RFI 72

Project: COOLEY LABORATORY RENOVATION
Job: 3146 COOLEY LAB, PPA# 10-0023
Customer: STOFMT MSU BOZEMAN

Item: Elevator Foundation Shift Type: ARCH/STRUC
Reference: S3.3, S2.7, A1.1 Spec. Section:
Attachments: 2 Drawings

9 SECTION
SCALE: 3/8"=1'-0"

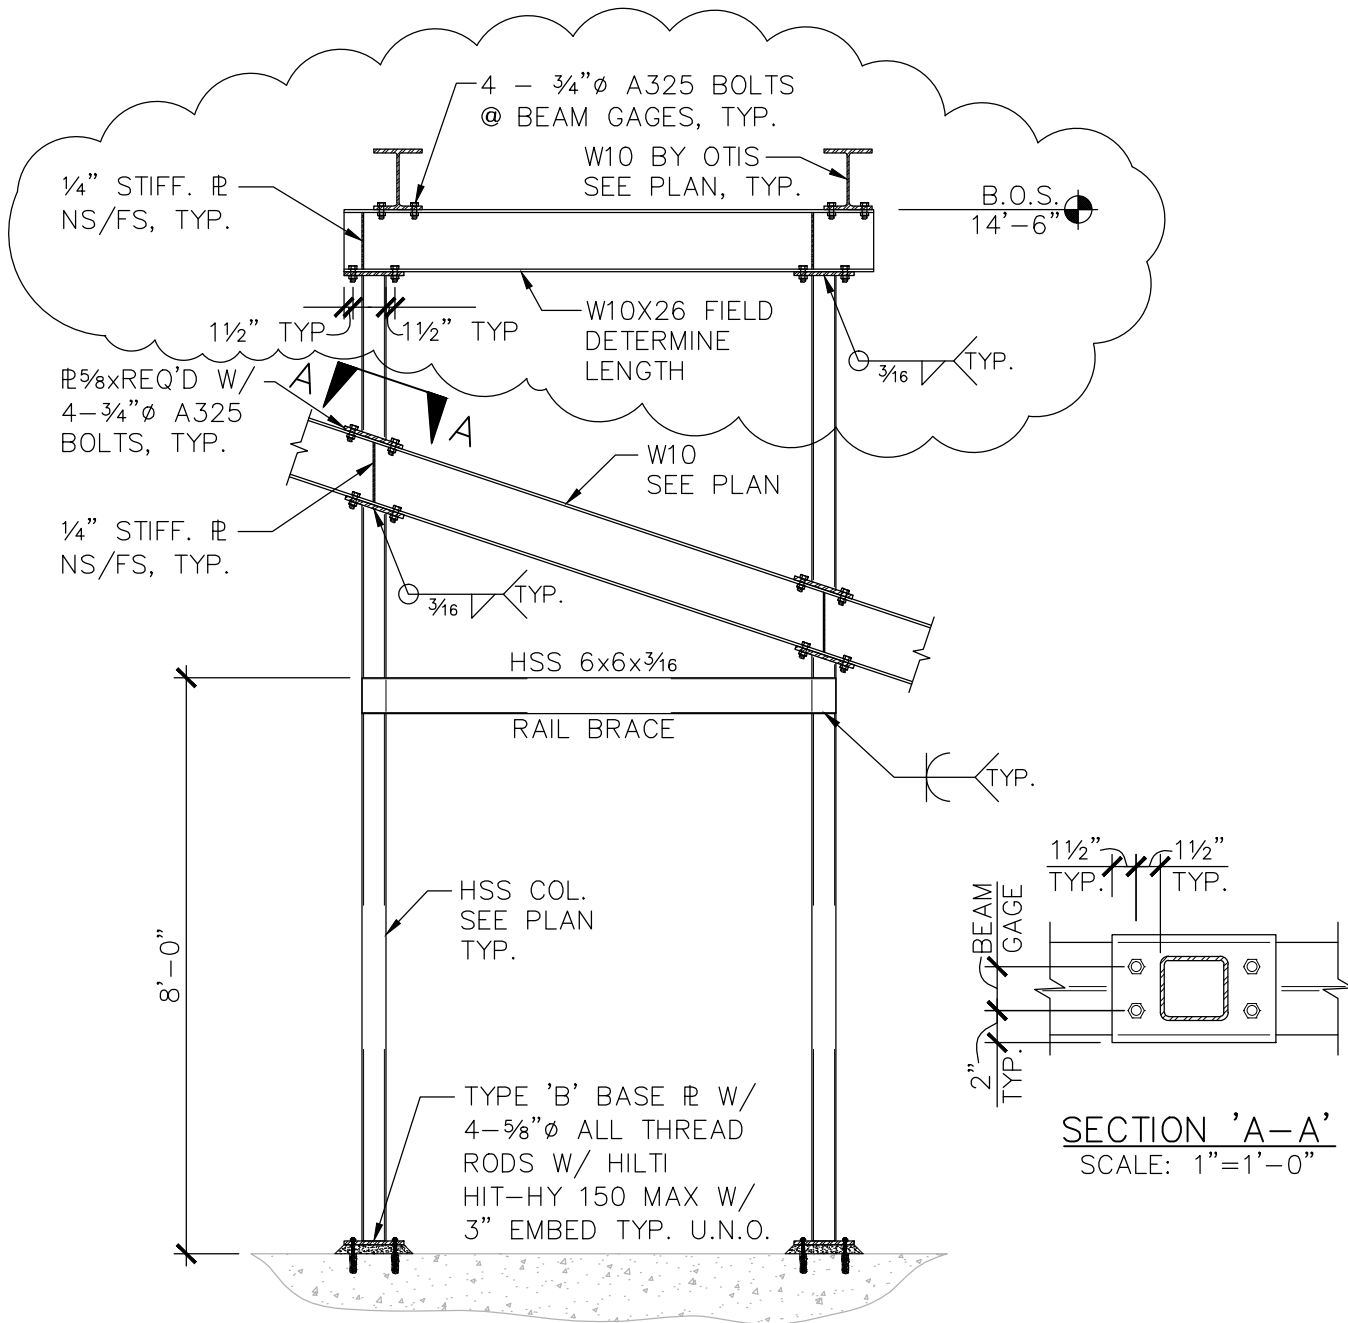
QUESTION:
The elevator pit foundation got shifted 4" to the north (see attached sketch 1). This occurred due to the fact the brick ledger at the time of layout appeared to be edge of foundation, "Gridline A".

We propose to make the grade-beam and wall bigger along gridline B .8, so the CMU walls on the 1st floor are per plans, (see attached).

We propose to either shift the upper grade-beam along gridline A to the north or make a larger grade beam along gridline A so the 1st floor cmu wall and framed wall are per plans, (see attached).

The ramifications of these proposed moves as DAC sees it are as follows:
The basement elevator vestibule entrance is made smaller by 4" due to the concrete wall encroaching in on it, but the overall size of the elevator vestibule remains the same due to the fact the elevator pit also shifted 4" north.

All the elevator vestibules on 1st, 2nd, 3rd, and 4th

floor will get 4" larger. The mechanical chase behind

the elevator will get 4" smaller.

To make the proposed modifications do the following:

- 1. Increase the width of the wall along grid line B.8 to 16". Use #4's at 18" o.c. vertical each face and #4's at 12" o.c. horizontal each face. Provide new #4 dowels to match the location of the new southern vertical steel curtain. Use Hilti HIT HY-150 MAX-SD epoxy with 4.5" embed for dowels.
2. Increase the width of the grade beam along grid line B.8 to 1'-10". Keep the location of the two CMU walls per the drawings.
3. Shift the location of the 12" vertical wall along Grid Line A 4" to the North. Leave the upper grade beam, CMU wall, and steel stud wall per the drawings.
4. Since the elevator will shift 4" to the north, Detail 9/S3.2 will need to be modified to provide support for the elevator beams. See attached drawing F-7.
5. DAC to confirm that no other material changes will occur due to the change in location of the elevator.
